**ATR on Quality Control Check Report. (Bungalows)**

Bungalow No	26	QC report stage		Sl. No.	30227
Company	Saan-Construction	Project	Saan-form	Phase	
Prepared by	Syed yalam Saan	Sign	Syed yalam Saan	Date	28-05-18
Project Manager	Belomandi kashira	Sign	<i>[Signature]</i>	Date	28-05-18
Receipt by QC date		Sign		Other	
Receipt at HO date		Sign		Other	
Checked By MD on		MD Sign		For filling	<input type="checkbox"/> Yes <input type="checkbox"/> No

Quality Control Check Report. Stage: After Column Casting (villas)

Description: VILLA 26 (TYPE 2) GC CHECK PLAN COLUMN/PEDESTAL	Direction N	Owners & Developers: Modi Properties Pvt.Ltd.	Date: 15/02/2018	Promoted by: Modi Properties Pvt. Ltd.
		Project Name & Phase: SERENE FARMS	Prepared By: Madhav	Phone:+91-40-66336651
		Approved By: Soham Modi	Scale: N.T.S

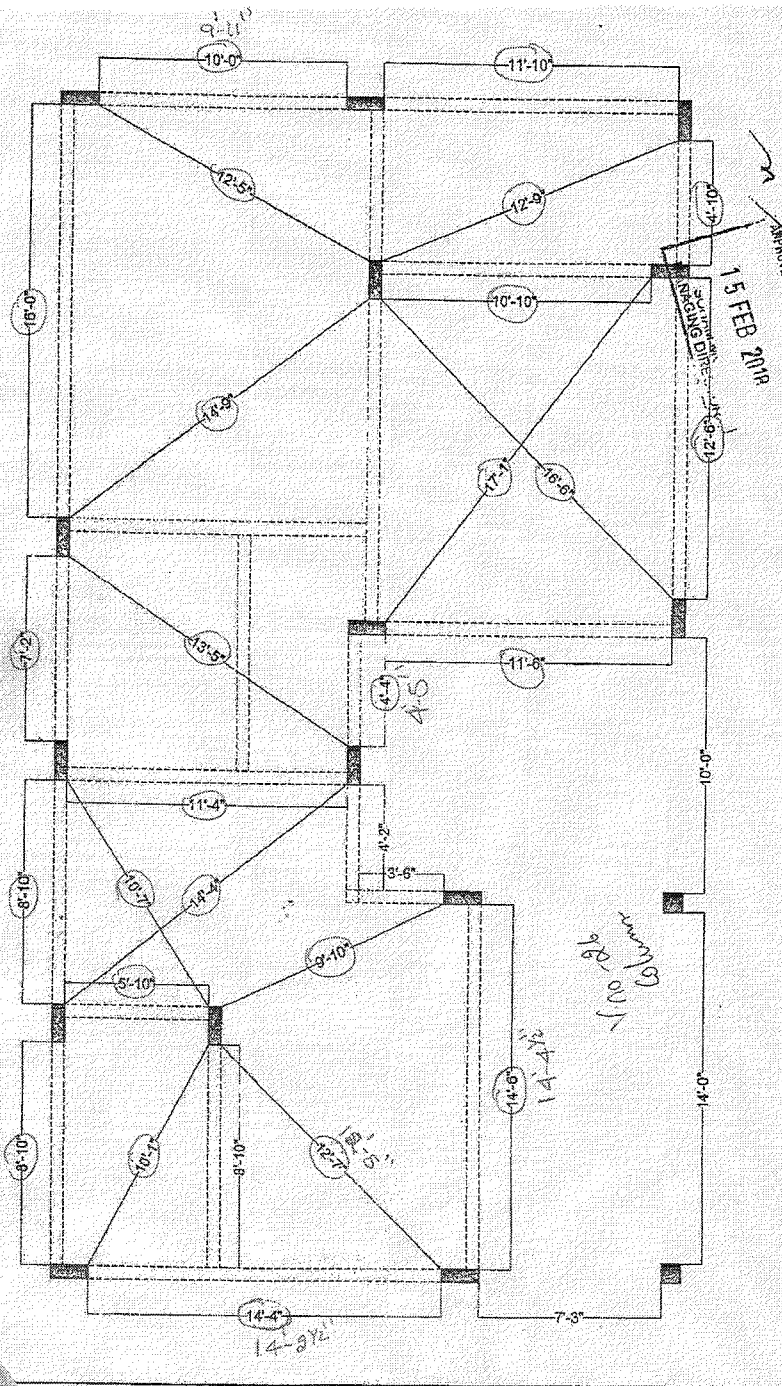
Columns Position Check.

- Inspection should be done after casting of columns at each stage and before starting centering works for each slab.
- Prepare Columns Position Check Plan as follows:
  - Divide blocks into smaller sub-blocks.
  - Show size and orientation of columns. (Tolerance 0.5")
  - Show inner - inner space between columns. (Tolerance 1")
  - Show diagonals for 20% of bays. (Tolerance 1.5")
  - Print an A3 size plan.
- Circle each correct dimension with green colour. Circle each incorrect dimension with red colour and mention actual dimension next to it.

*Work done*
